Asbestos Landfill

Loring Air Force Base

FINAL CONSTRUCTION REPORT

November 1999

APPROXIMATE  
EXTENT OF  
STEEP SLOPES  
TO BE  
REWORKED

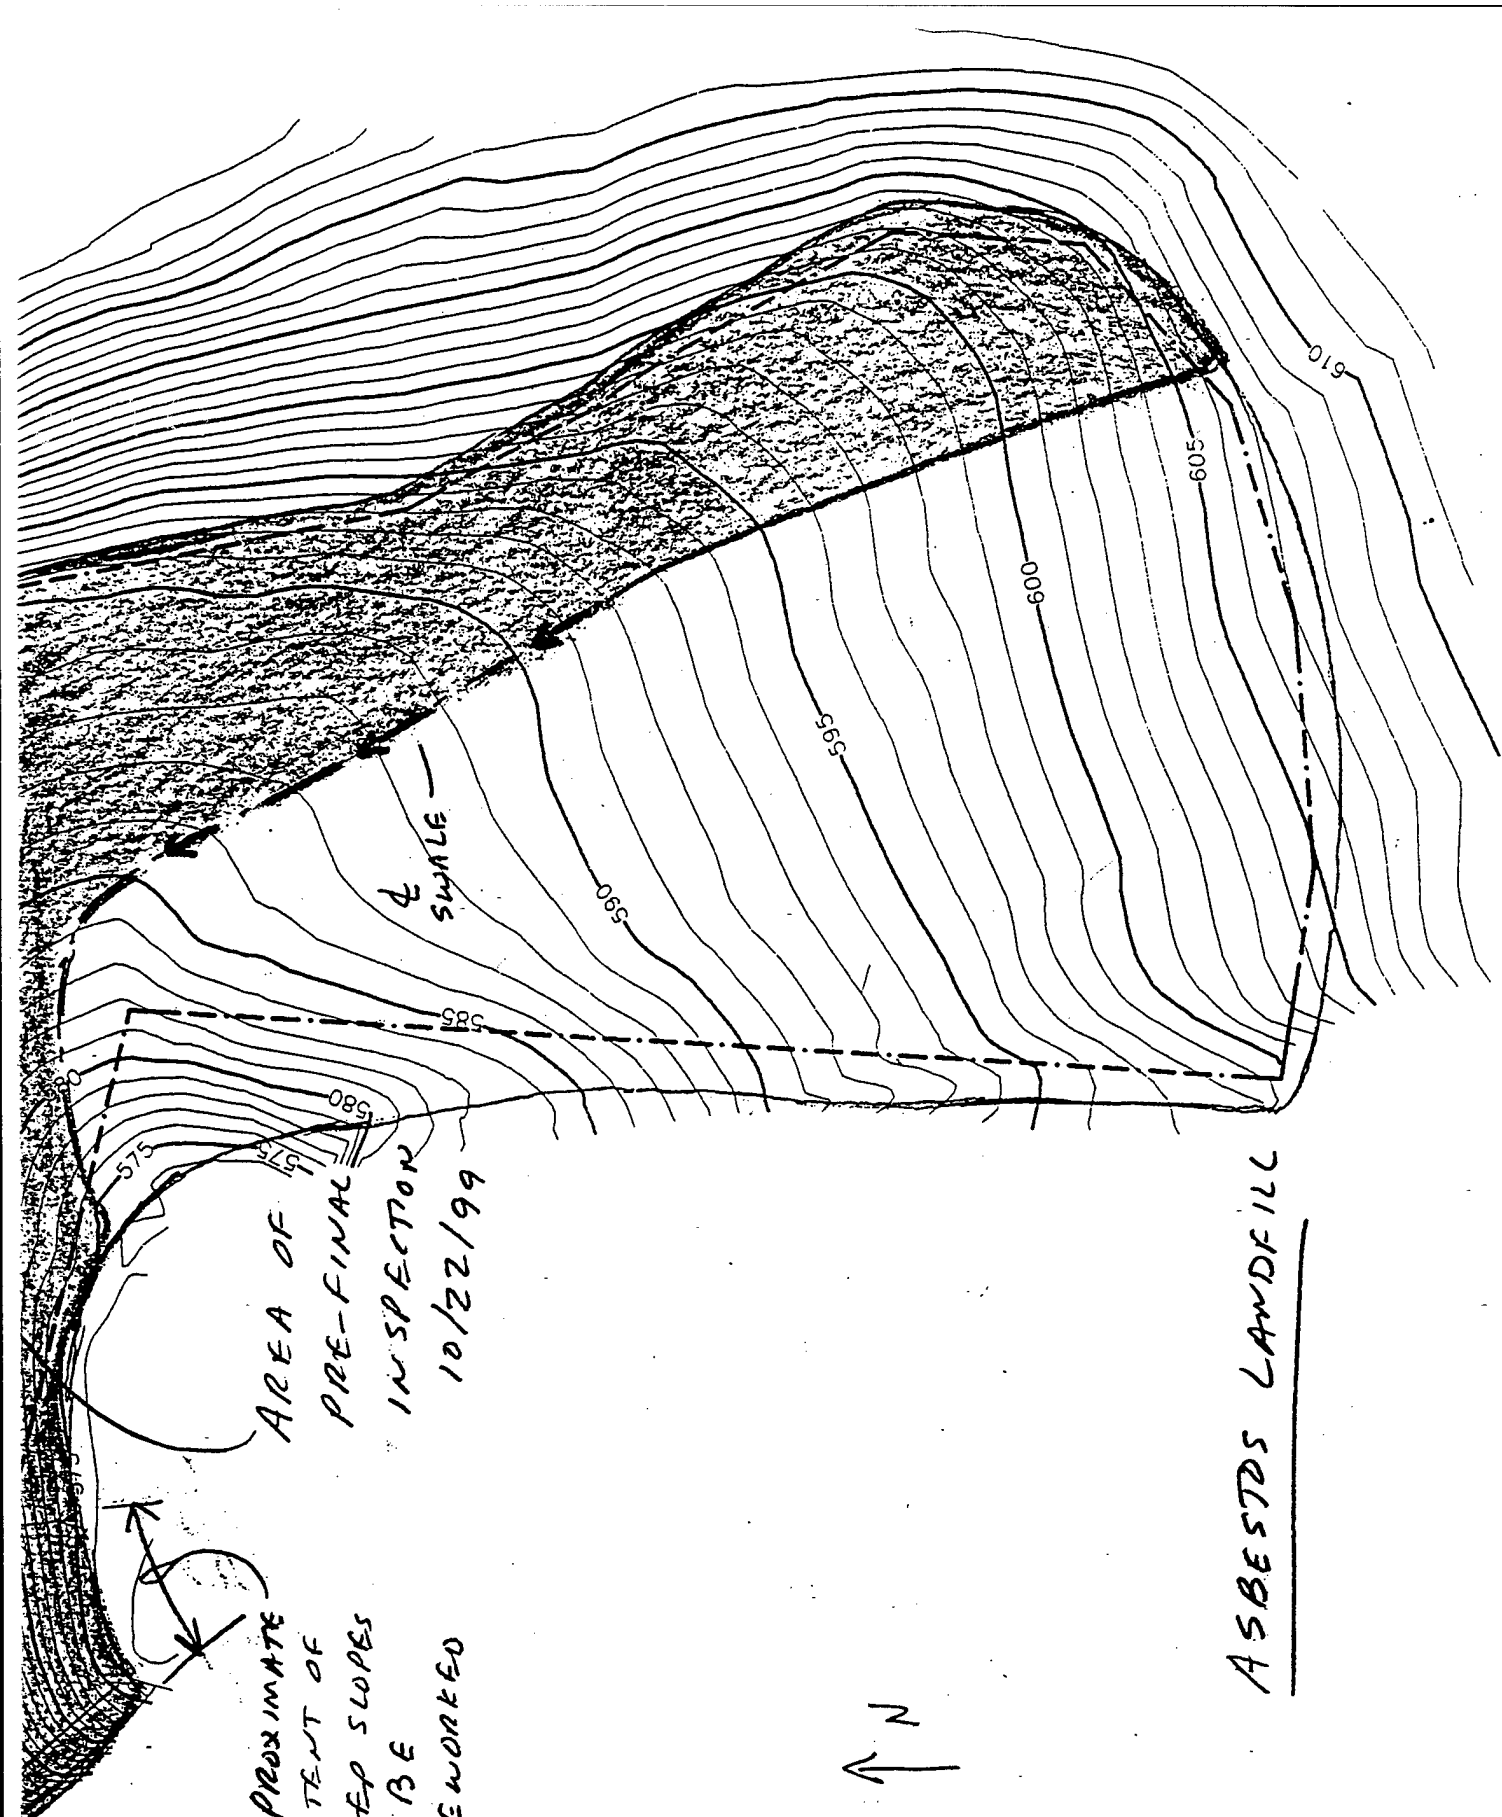
- 1) Subject to rework of steep slopes in NW section  
of landfill (refer to sketch) - must be  
reshaped to be no steeper than 3:1
- 42) Subject to final topo

# SBESTOS LANDFILL GRADING PLAN

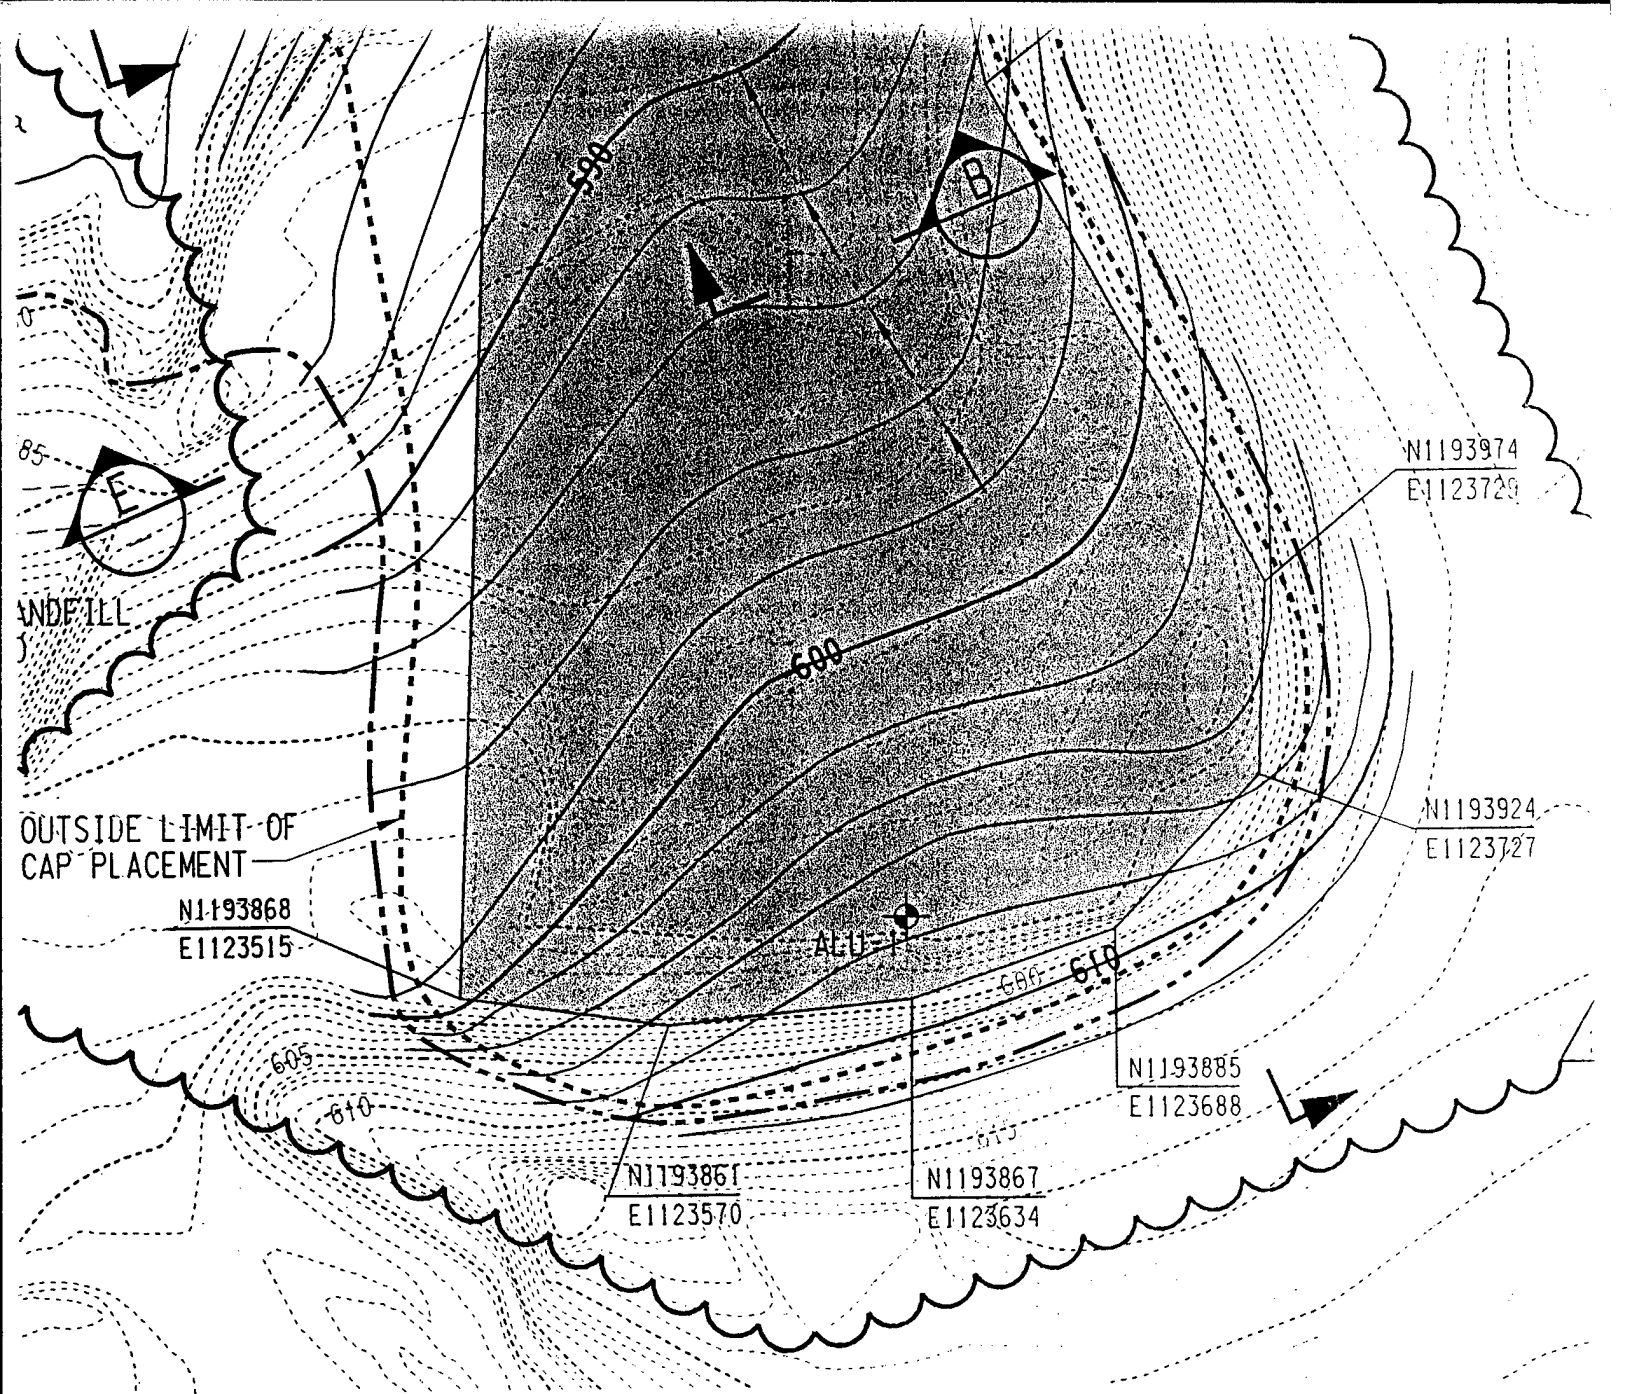
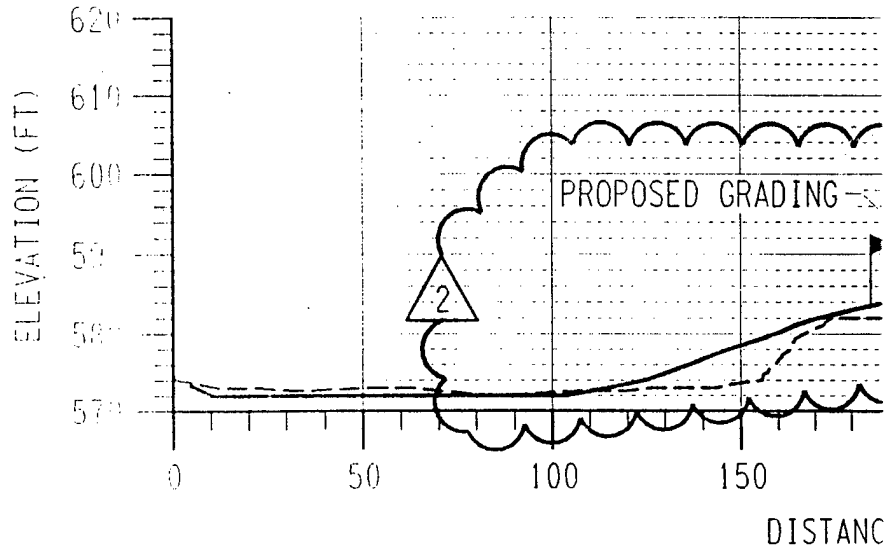
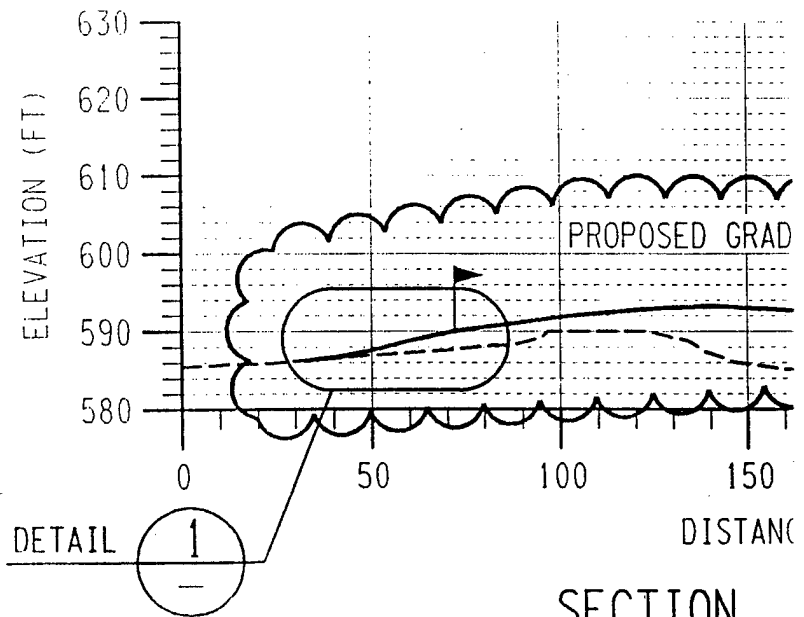
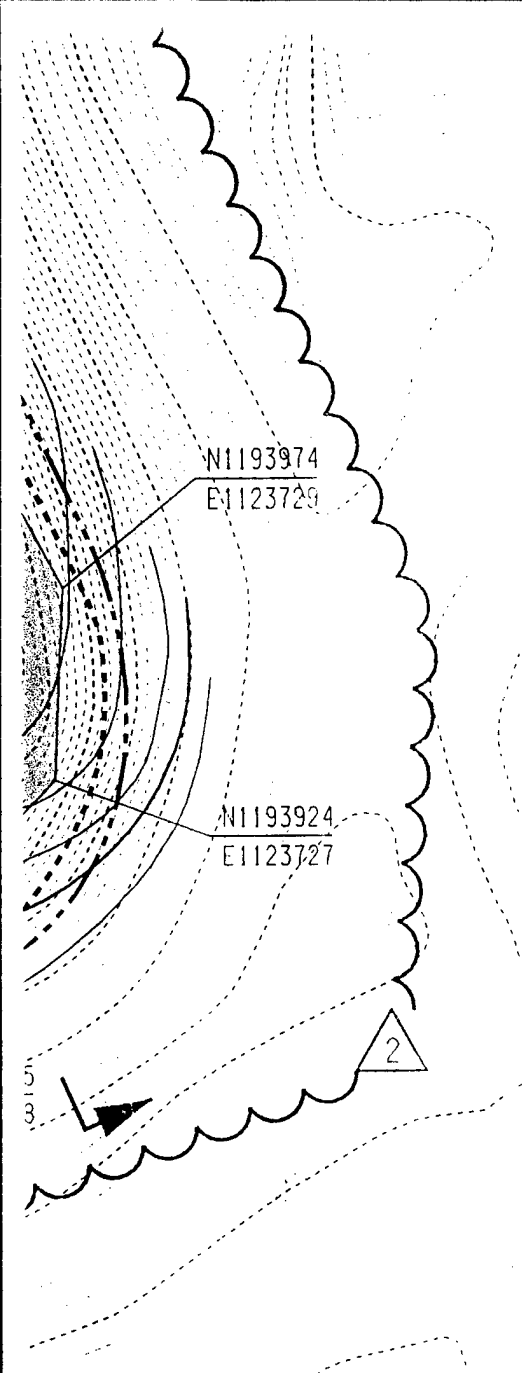
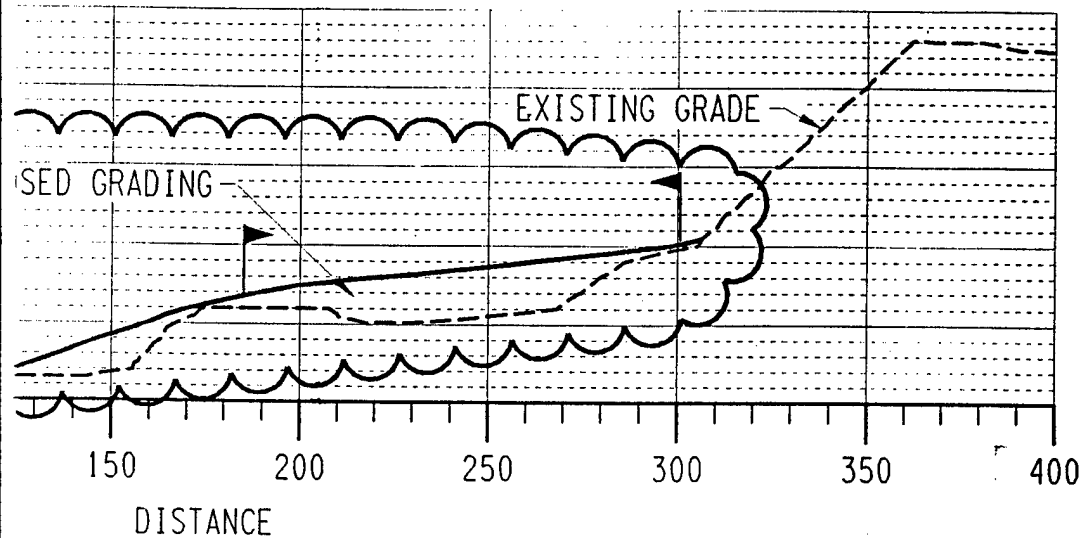
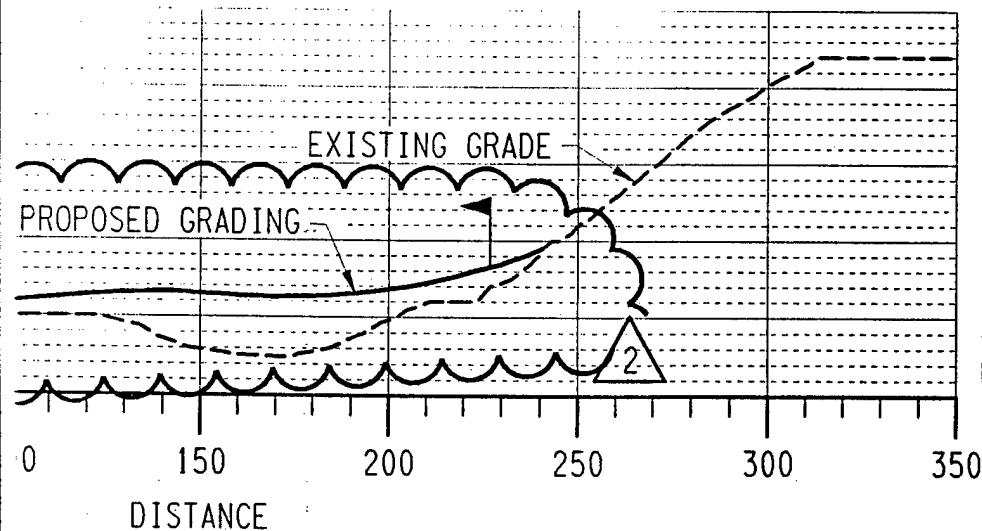
Request concurrence on the revised boundaries of the asbestos waste at the Asbestos Landfill. Please see attached drawing 007-DD-002 Revision 2.

The boundaries were revised based on field conditions and will minimize the amount of common borrow to be placed.

The limits of waste shown on the plan view of the drawing should represent what was staked in the field. However, the waste limits shown(flag symbol) in the sections A,C,D, and E do not match up with the plan view. The final drawing should be corrected.

I would recommend we commence the cap using the staked locations in the field while the drawing is being corrected. I would like to send a corrected drawing to DEP asap. DH
